**RE: 285 River Road & 357 River Road – Proposed 11 Lot Resubdivision – Putnam, CT
P&R Job No. 203095**

Attached please find three copies of revised plans for the above referenced project. The plan revisions have been prepared to address comments in a January 17, 2023 letter from CLA Engineers, Inc. The following responses correspond to each review comment:

PROPOSED 11 LOT RESUBDIVISION

EXCAVATION PLAN No. 1

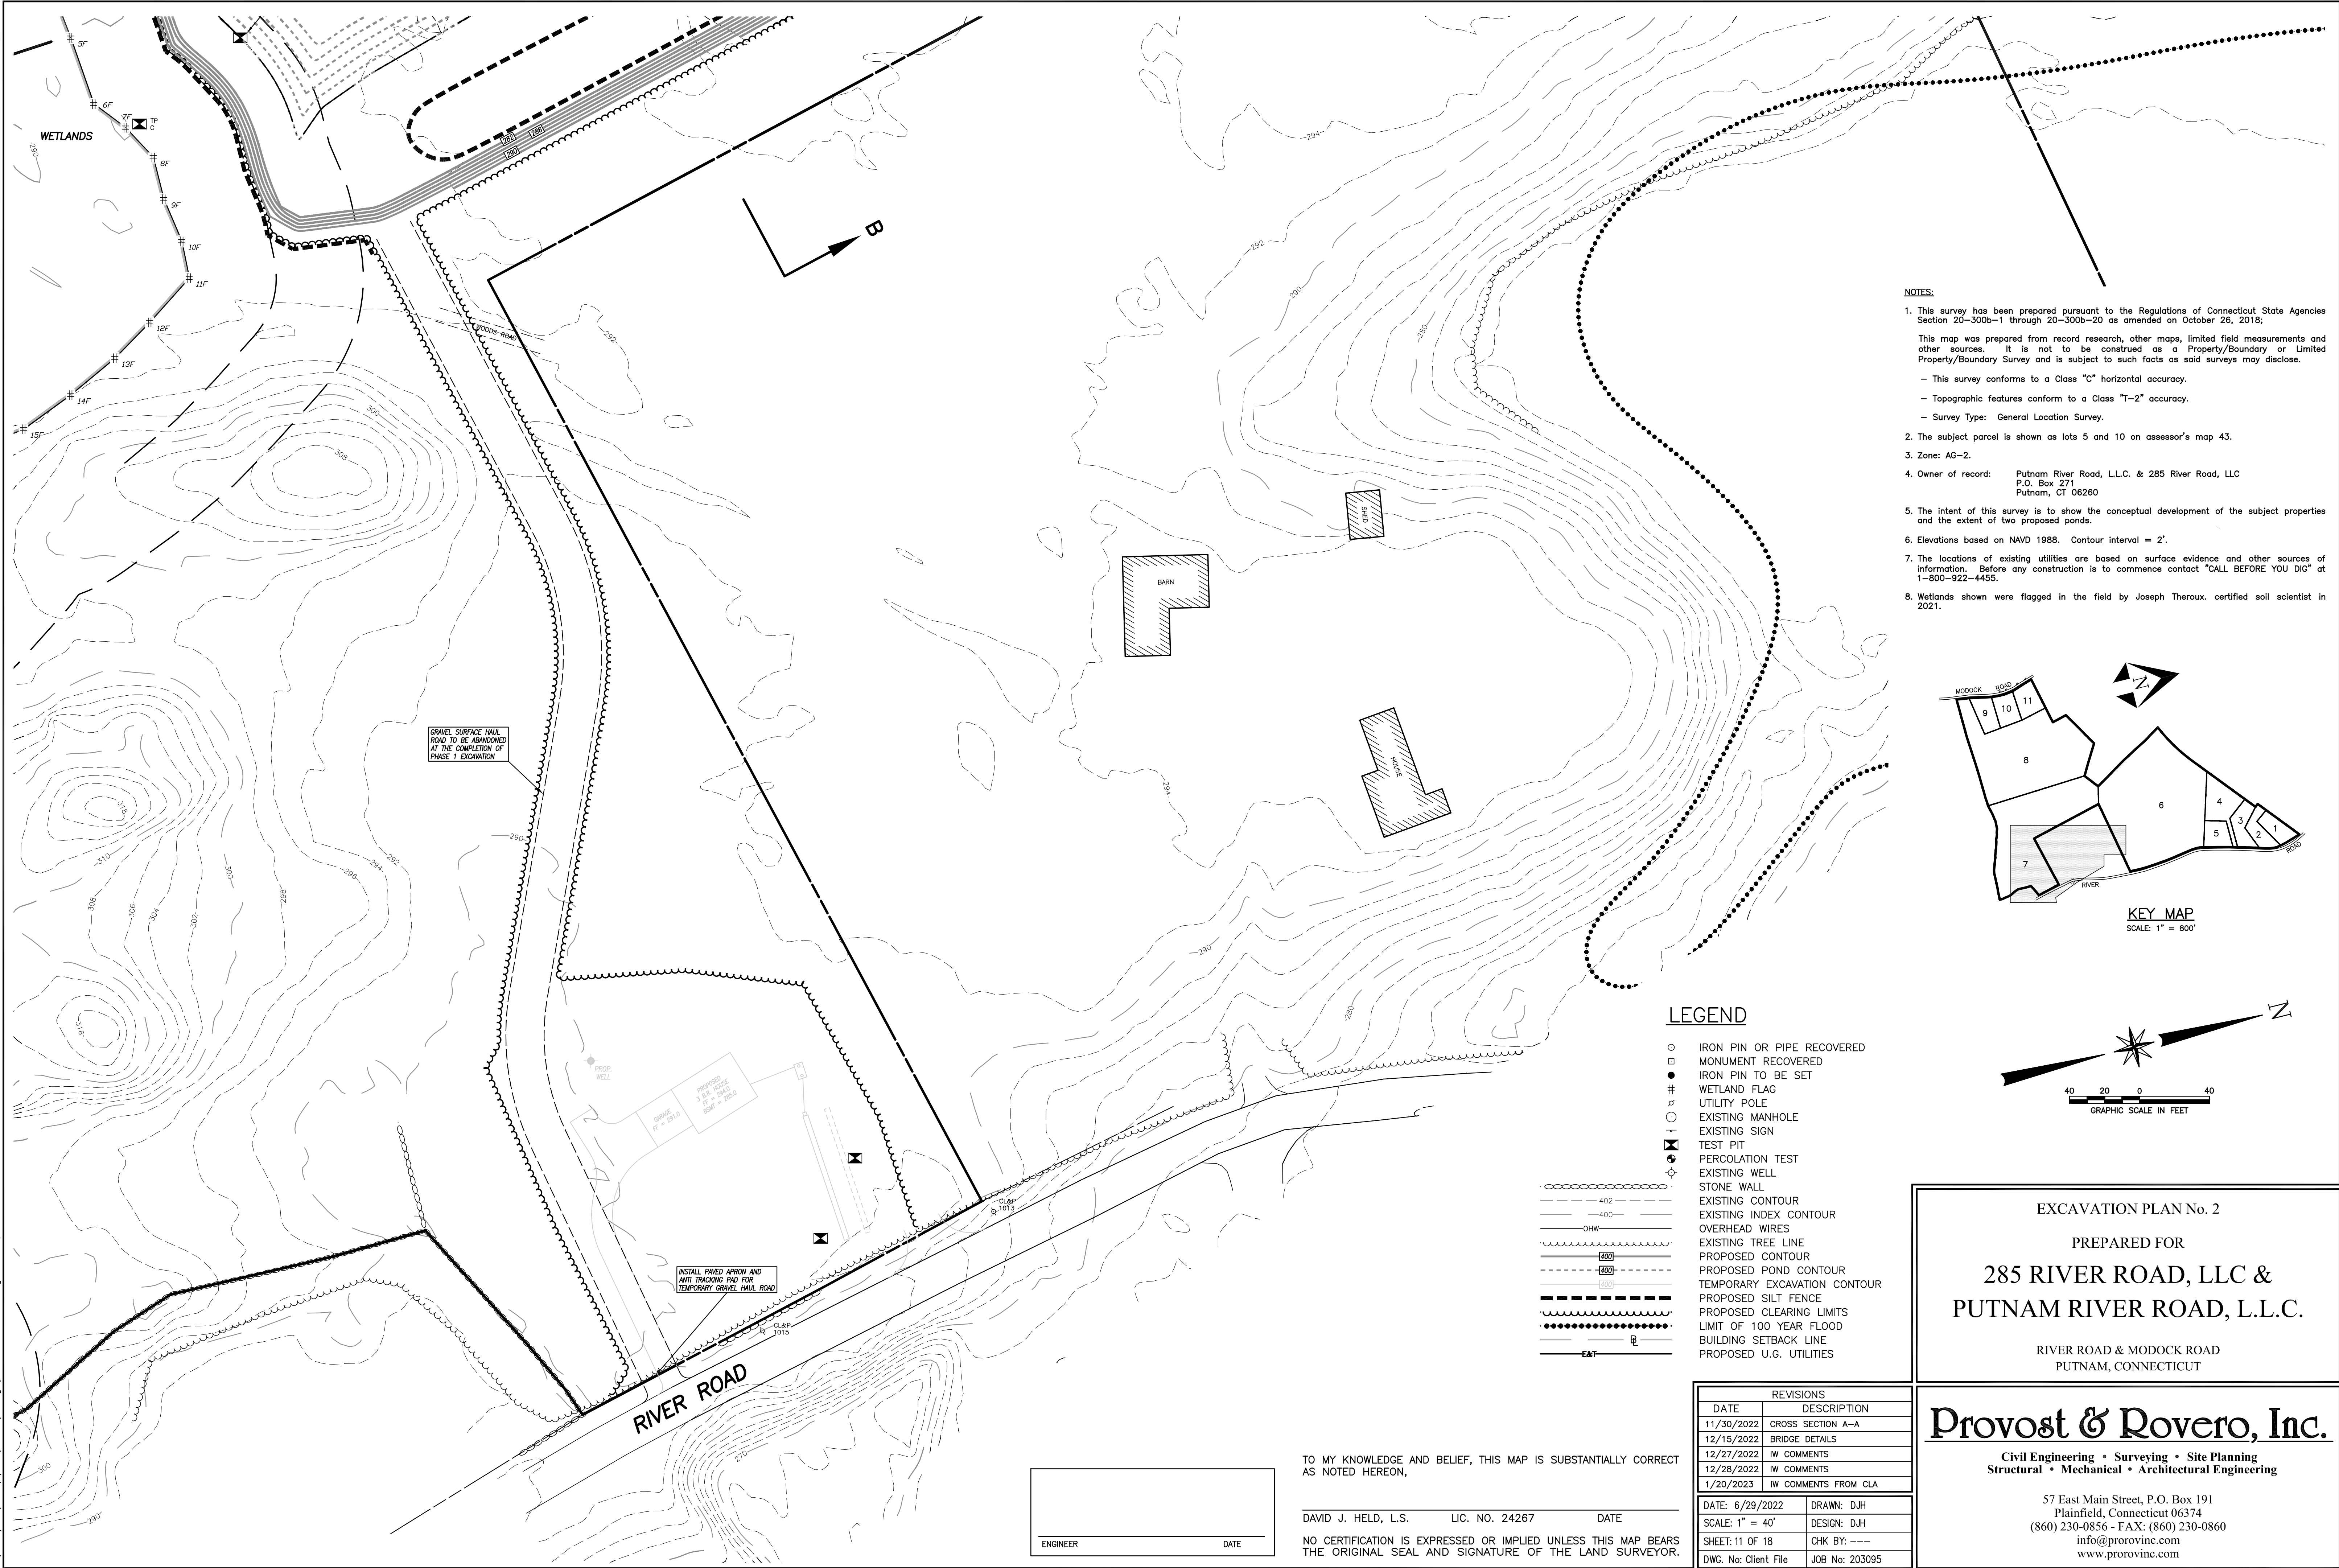
1. Feasible soil stockpile areas have been shown for each lot and for each excavation area. Note that the topsoil stockpile area for excavation area #1 could be constructed as a berm in the location shown to provide screening for the neighboring property.

4. Feasible dewatering areas for each excavation site have been shown. Note that dewatering will take place at the site of the actual material excavation which will be self contained from a storm drainage perspective.

8. The excavation notes have been revised and the excavation site plans have been revised to require temporary orange construction fence at the limits of clearing or limits of disturbance.
